Mercedes C-Class - Coolant leak from Intake Manifold

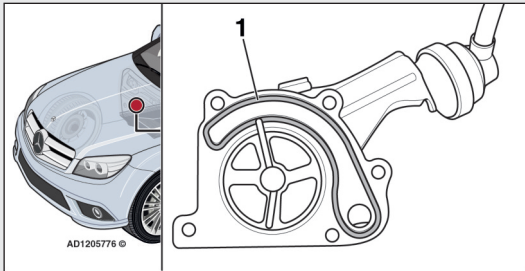
Question: We have a 2009 Mercedes-Benz C-Class in the workshop with a coolant leak. We have narrowed the coolant leak down to the intake manifold area but haven't managed to pinpoint the exact cause. We are reluctant to replace the intake manifold without solid evidence it is the cause. Can you advise?

Answer: We are aware of a coolant leak issue in the area of the intake manifold on Mercedes-Benz models, with a 651 engine code. The coolant leak is due to a faulty EGR cooler bypass valve seal. Fit a modified seal,

available from Mercedes-Benz parts department, to the EGR cooler bypass valve Fig.1.1. This should rectify the fault. Ensure engine coolant level and anti-freeze content are correct.
